## DESIGN REVIEW/CERTIFICATE OF APPROPRIATENESS APPLICATION

PROPERTY INFORMATION			
Project/Property Address: Hamilton Road		Project Name/Business Name: Orthopedic One Gahanna / Orthopedic One	
Parcel #: 025-013767-00	Zoning: (see <a href="#">Map</a> ) <b>SCPD</b>	Acreage: 9.13 ac

Attention: Kelly Wicker  
Planning and Zoning Coordinator  
RE: Response Letter #1  
Project Hamilton Rd Ortho One Design Review/C of A

LANDSCAPE PLAN - OVERALL SITE

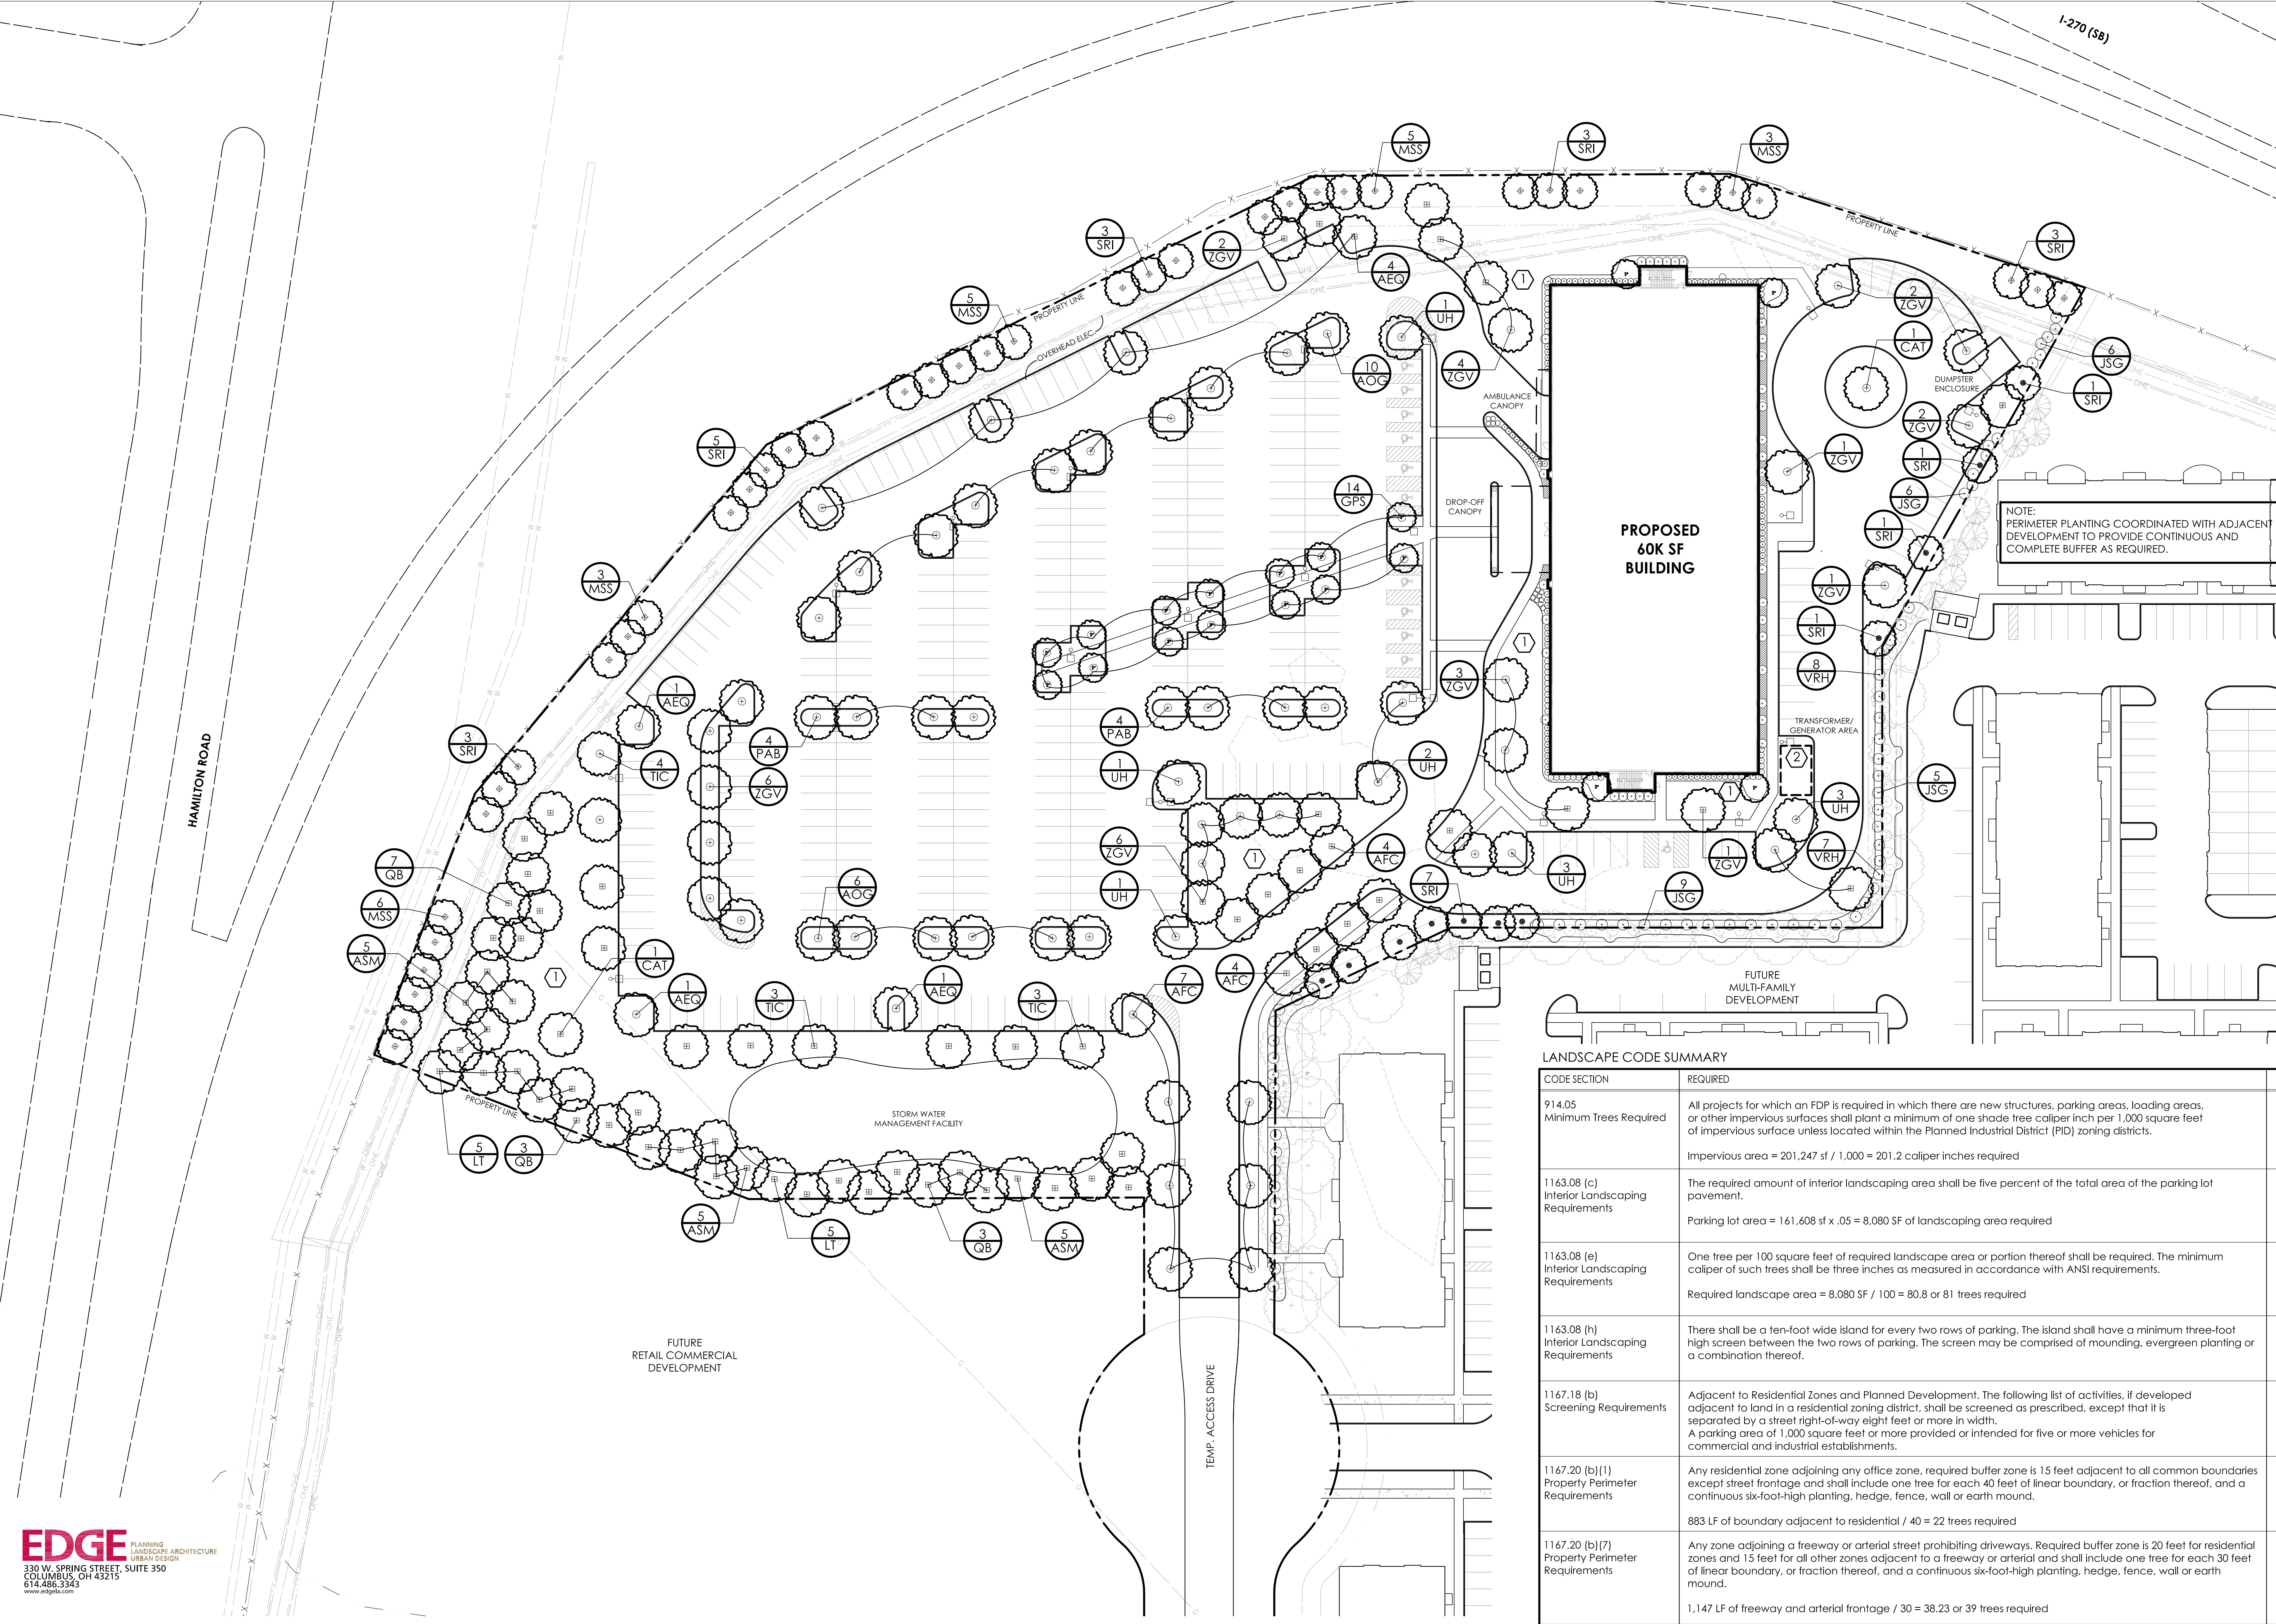
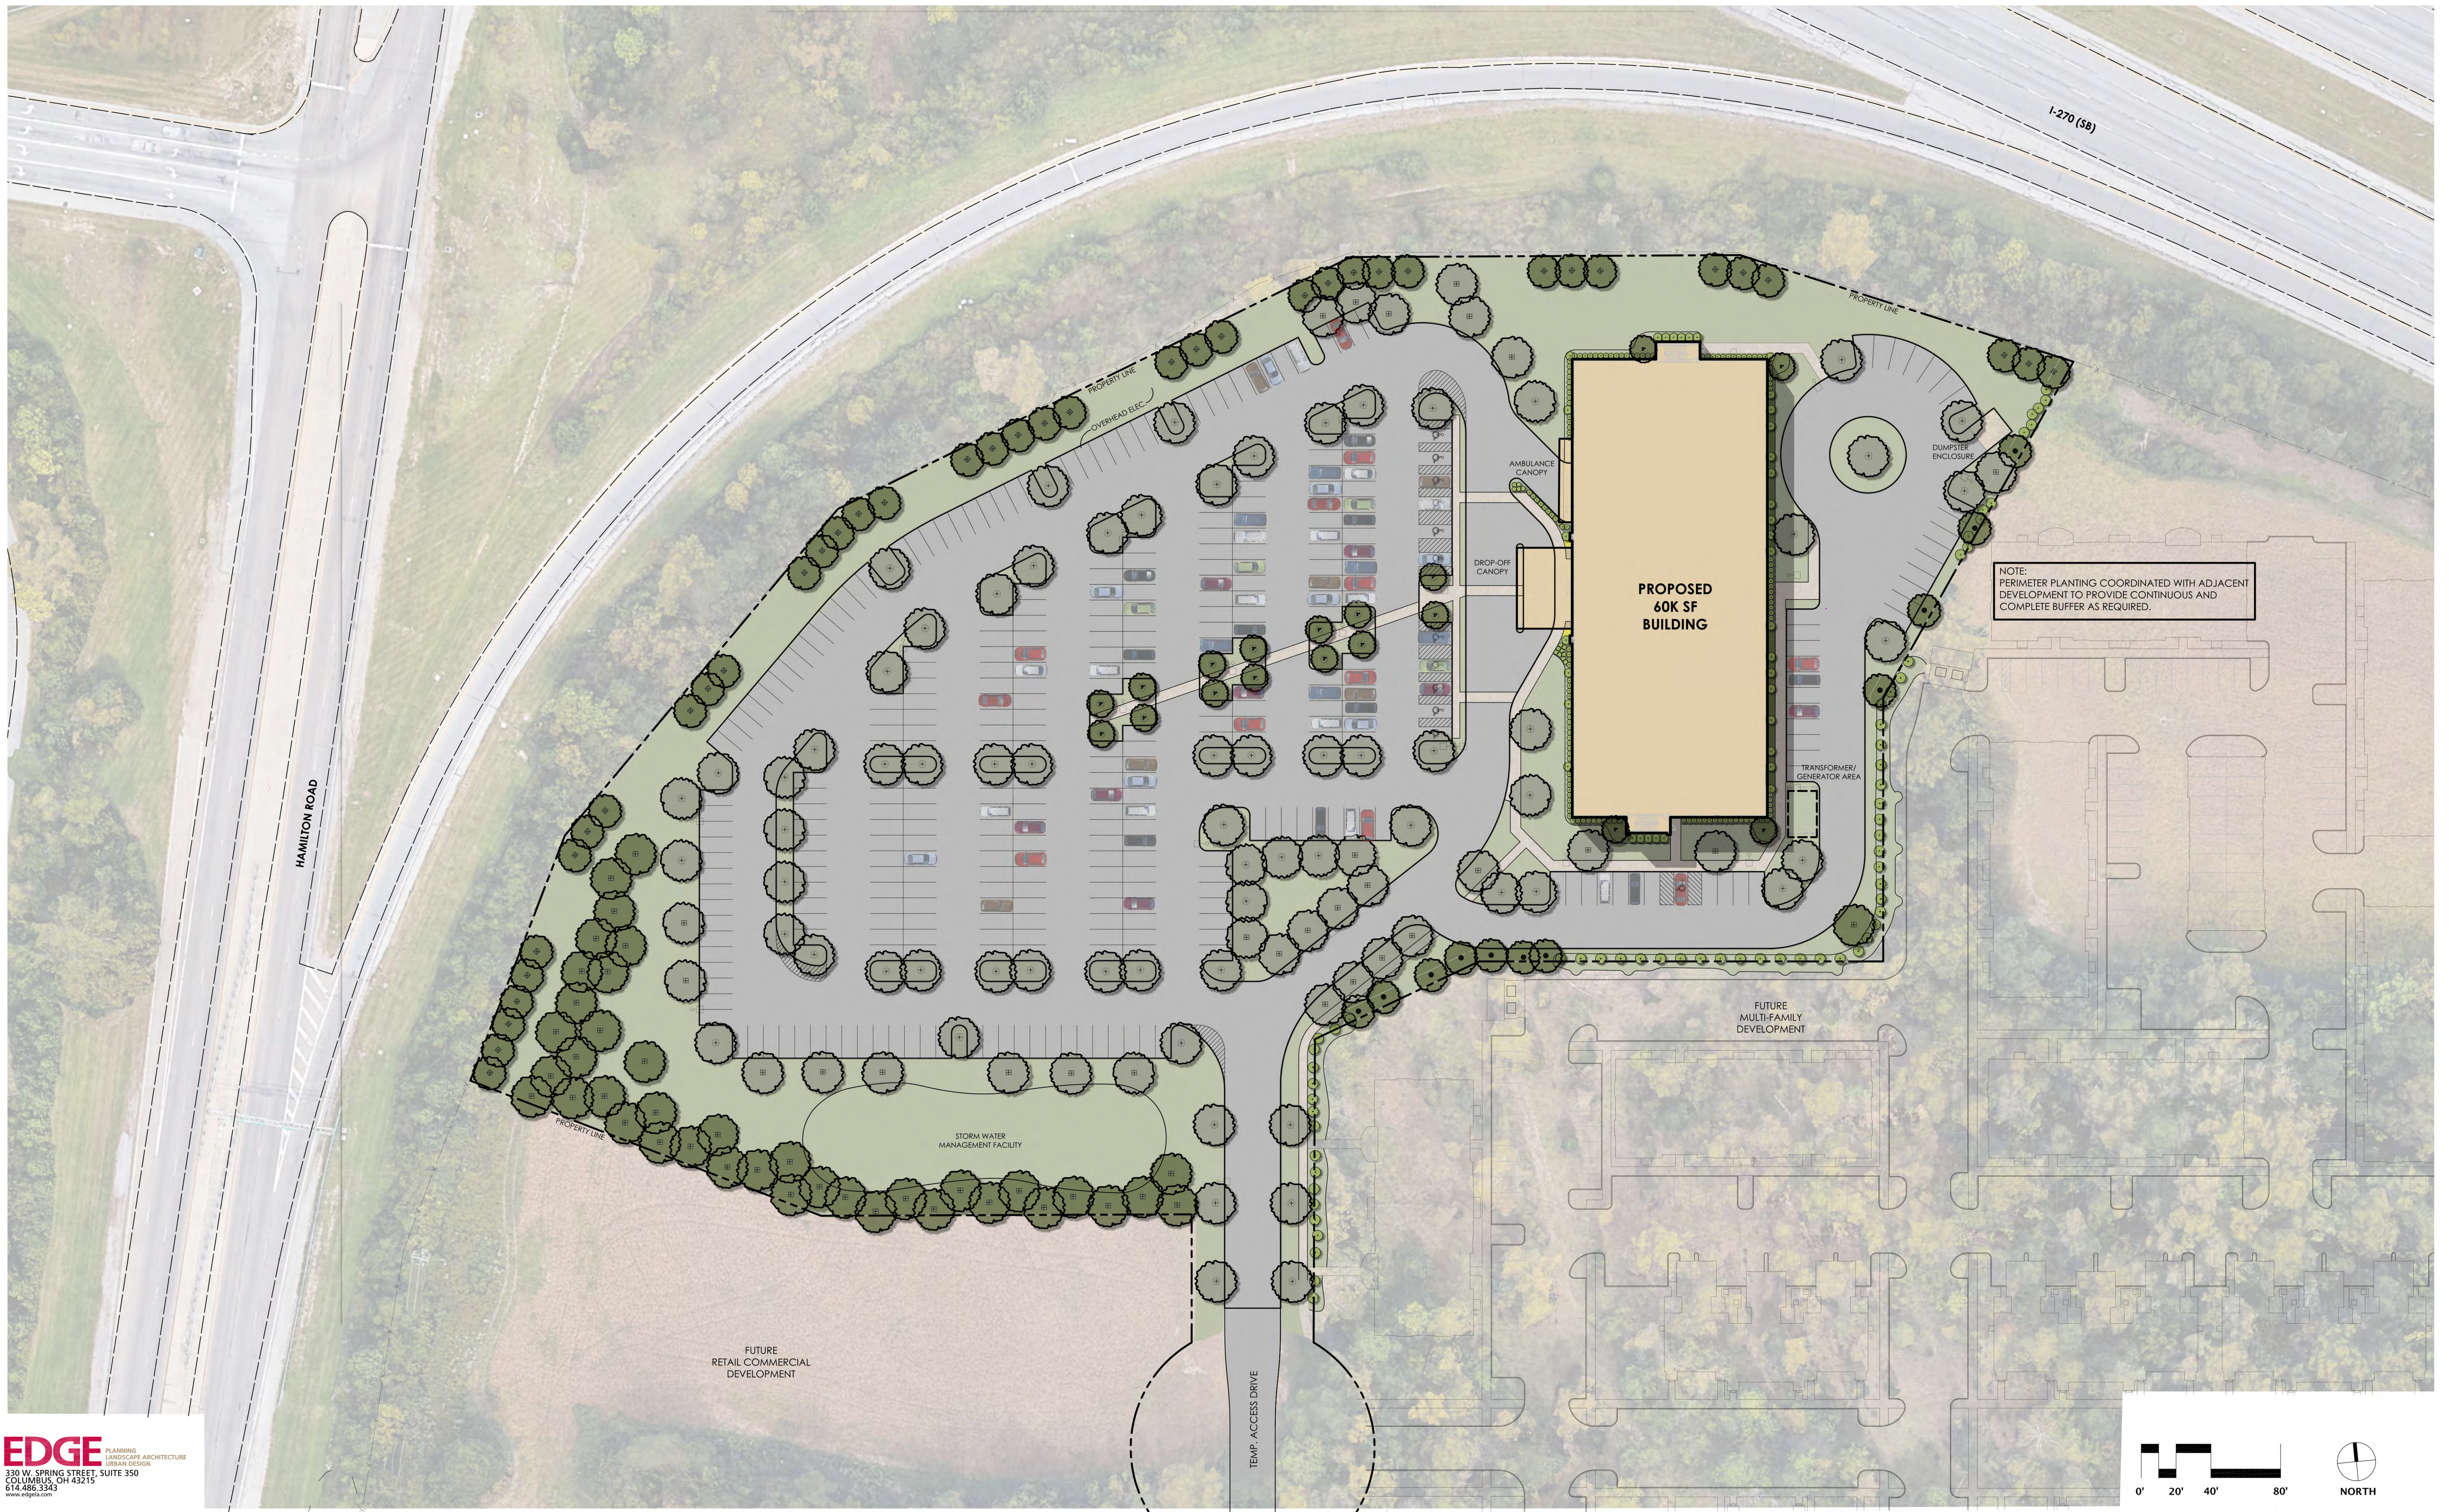
4. I see that plans call for clustered plantings to be mulched with river rock, but it looks like there are trees at the perimeter of the property surrounded by turf and trees in parking lot islands. Are these trees also going to be mulched with river rock? If they are going to be mulched with hardwood mulch, mulch depths and proper mulching technique should be mentioned in the plans. Organic mulch such as hardwood mulch is better for tree health than river rock.

**Response: River Rock specification is an error and will be revised to shredded hardwood bark.**
